ADDENDUM #3

March 8, 2013

Re: Harrisburg Area Community College
Central Administration Building
Phase 3 – Interior Fitout
Solicitation # RFB13-15

From: Eastern PCM, LLC
Construction Manager – HACC
645 N. 12th Street, Suite 200
Lemoyne, PA 17043

DRAWING NUMBER:
SKA-10
PHASE 3

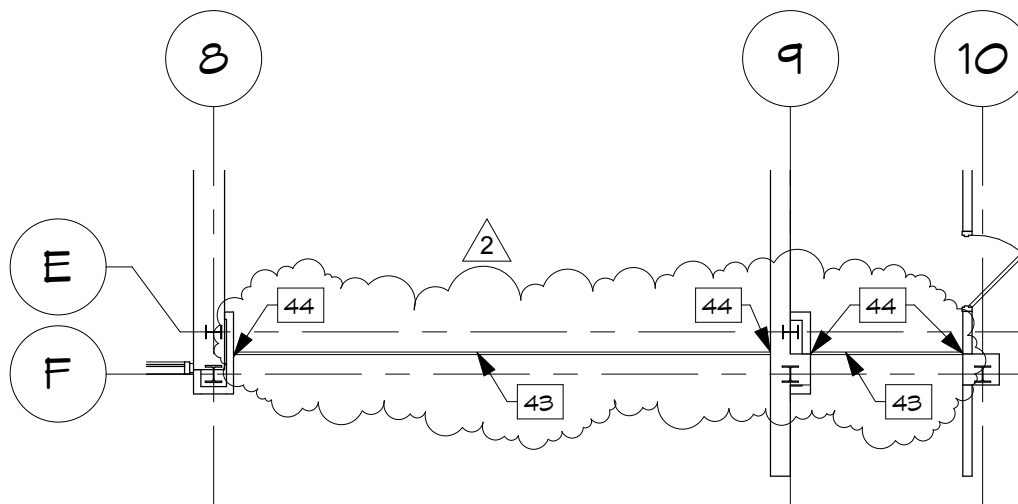
- A. Drawing X2.4: REVISE this sheet per SKA-10.
- B. Drawing X2.6: REVISE this sheet per SKA-11.
- C. Drawing A2.4: REVISE this sheet per SKA-12.
- D. Drawing A2.6: REVISE this sheet per SKA-13.
- E. Drawing A6.3: REPLACE this sheet in its entirety.
- F. Drawing A7.12: REVISE this sheet per SKA-14.
- G. Drawing S0.1:

1 BOARD ROOM 103 ENLARGED PLAN - LIGHTING CONTROL
E5.1 1/4" = 1'-0"

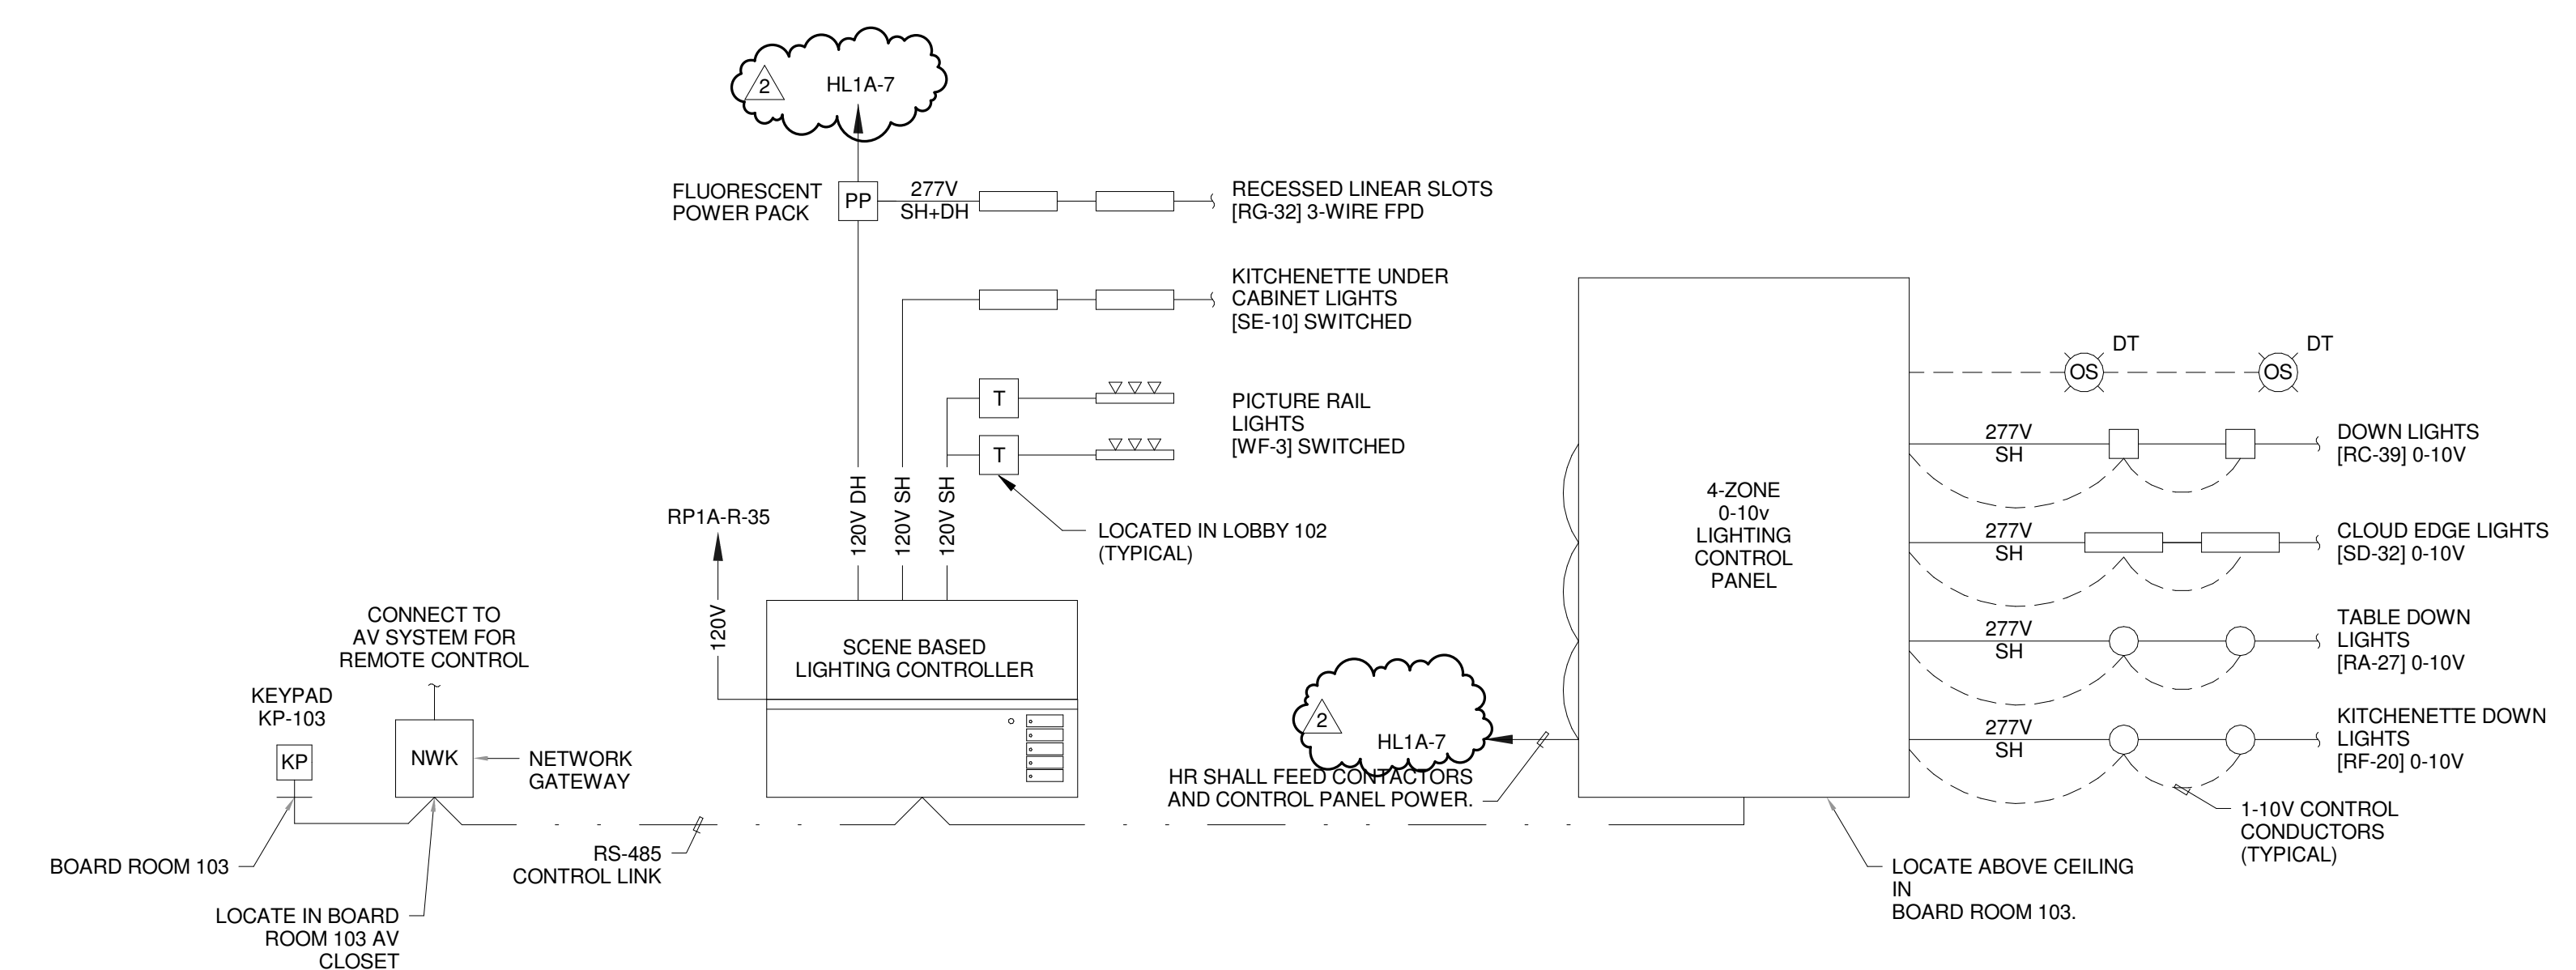
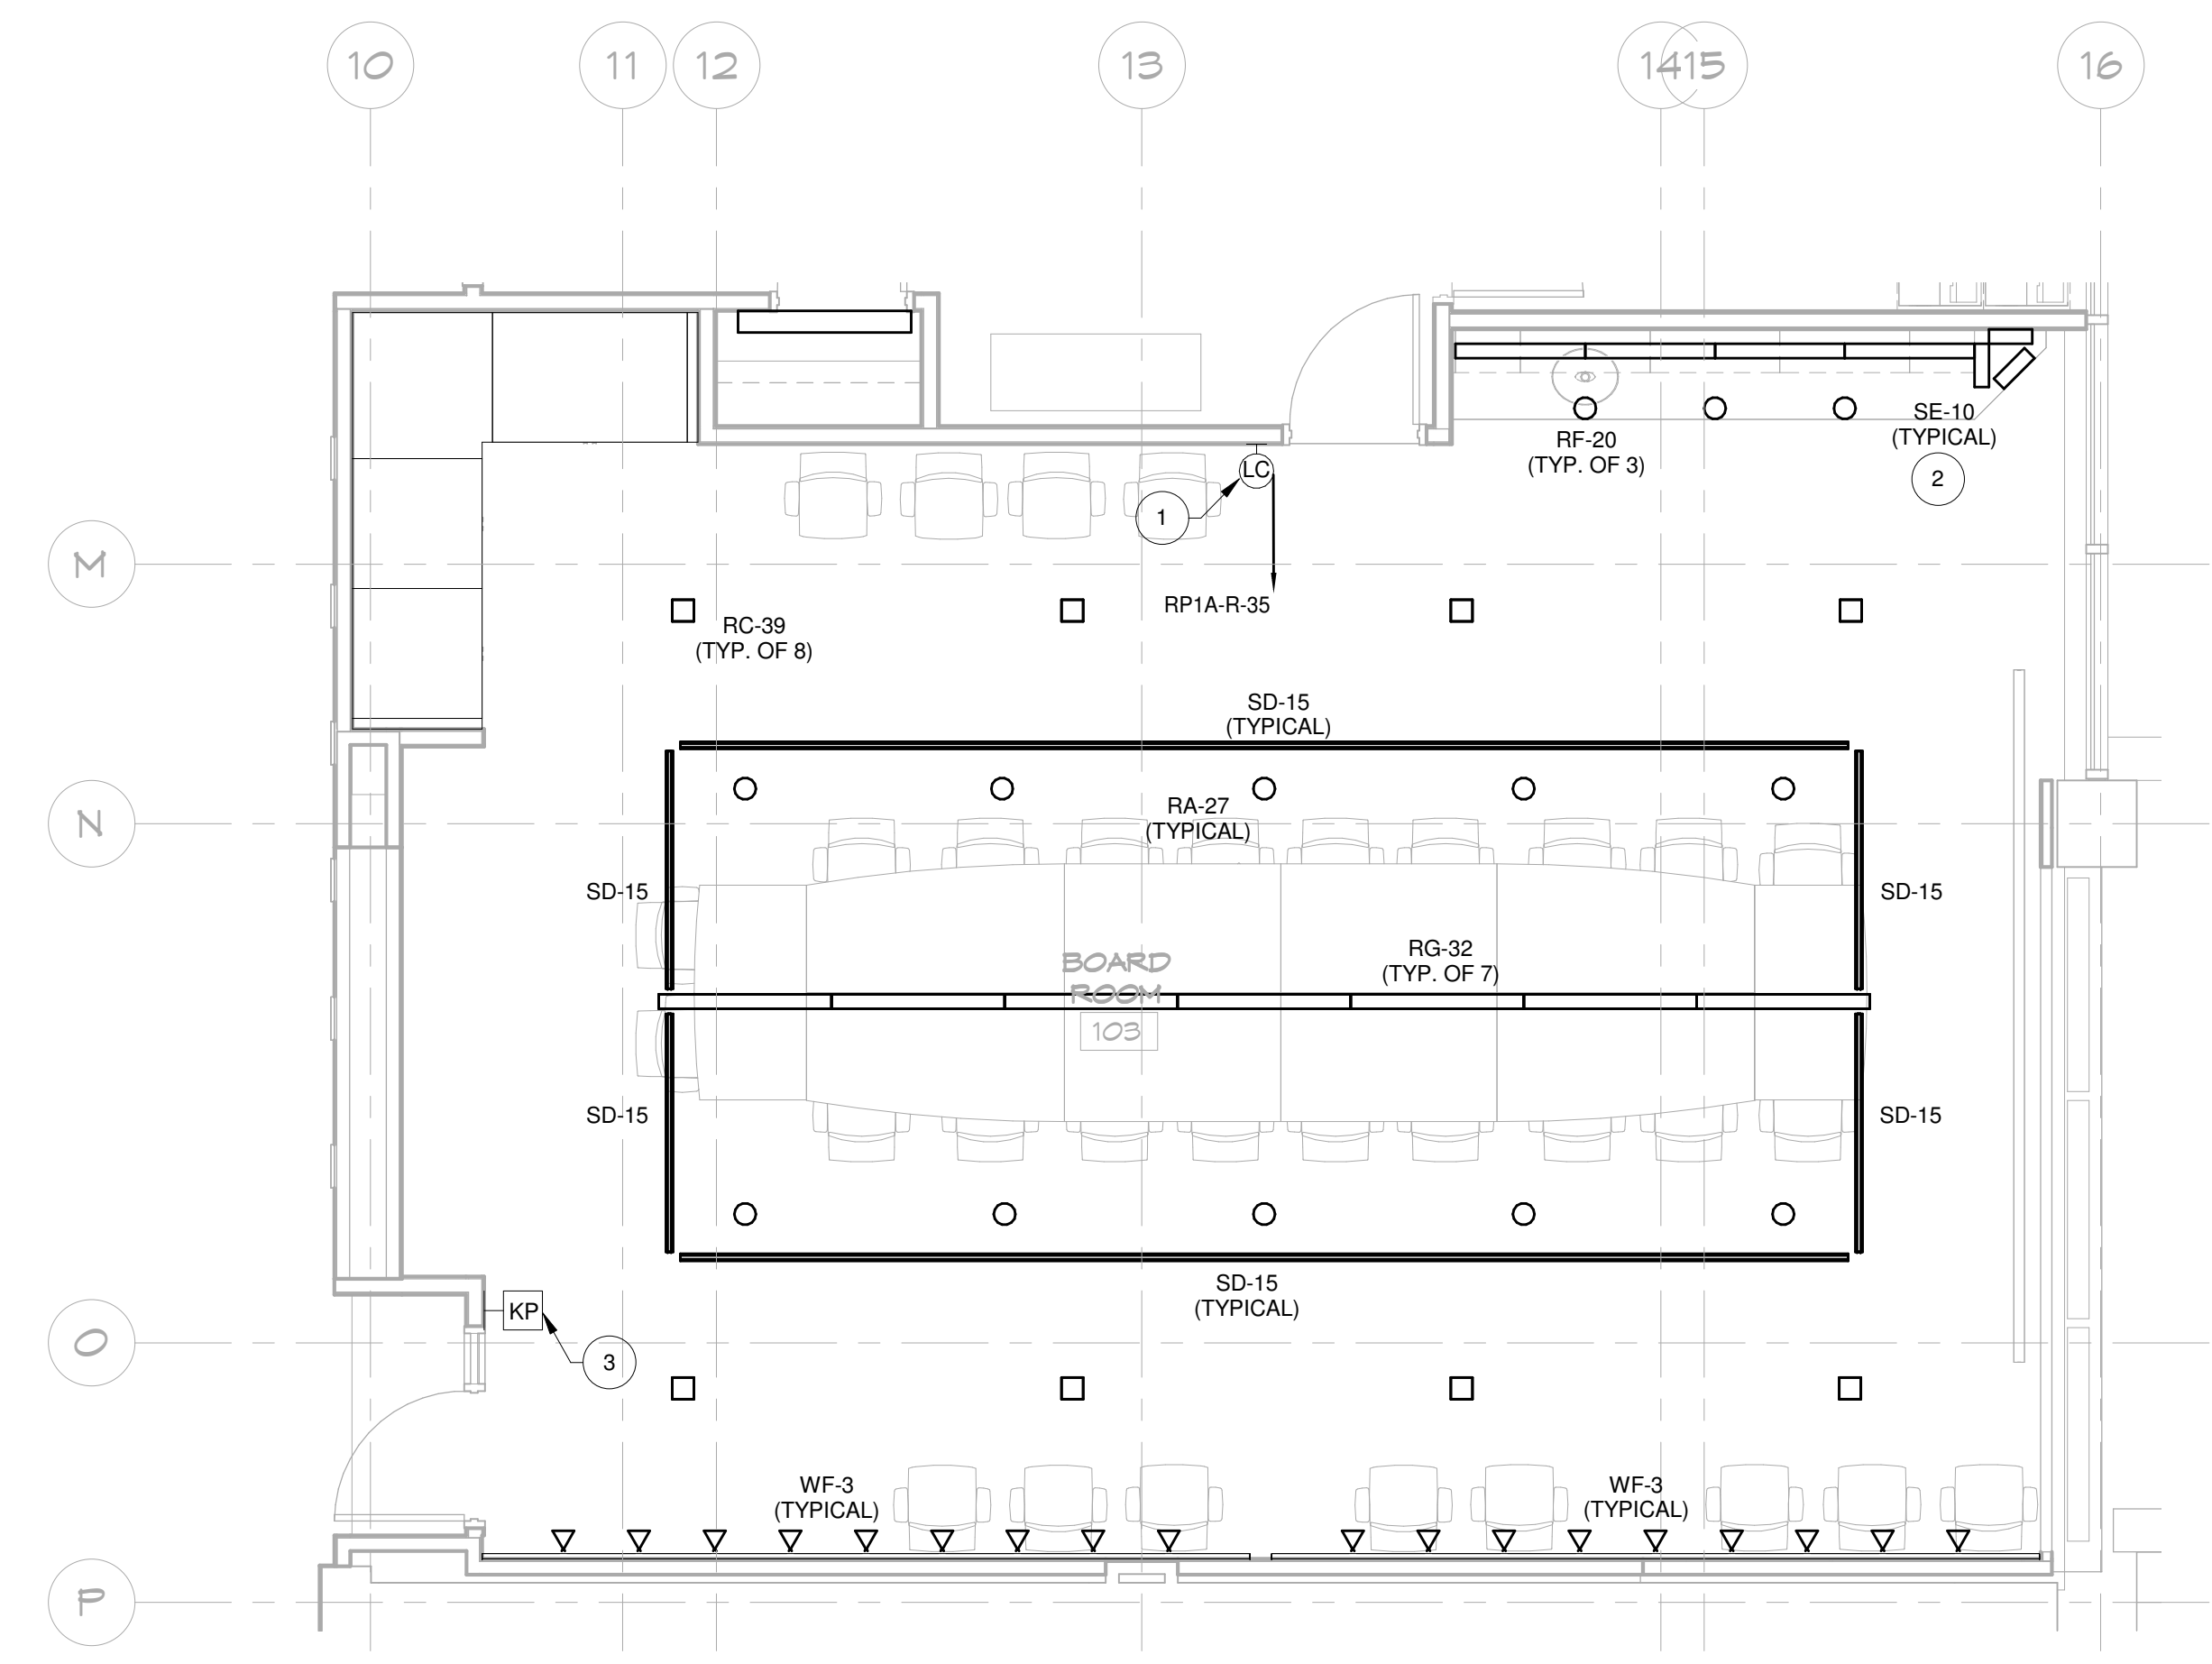
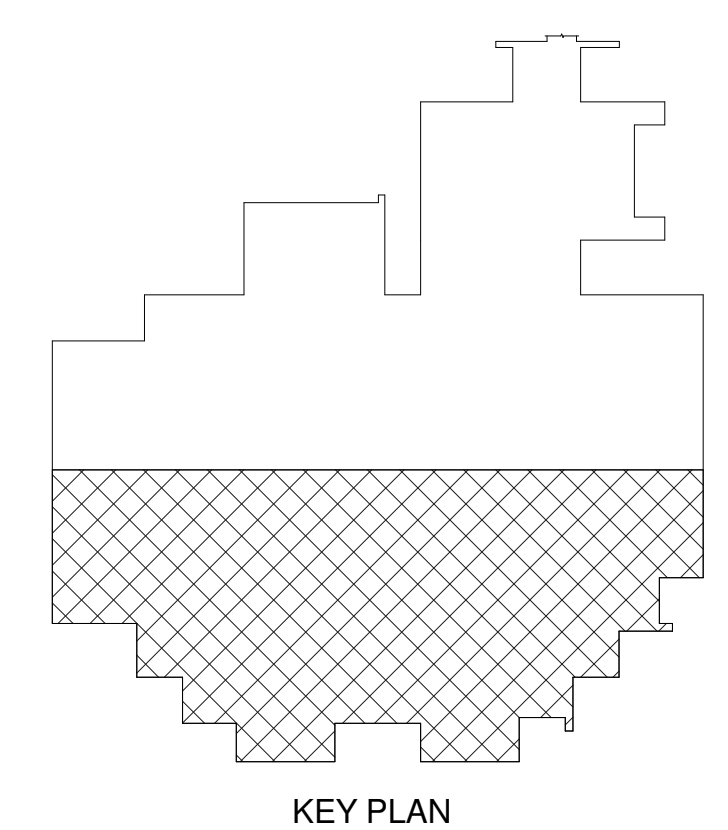
- K. The furniture is existing and includes a whip for connection to floor boxes.
- L. Dimming is not required in Mens 110, Womens 111, Mens 203, or Womens 204. Provide single pole switches, occupant sensors, and automatic load control relays per the contract documents.
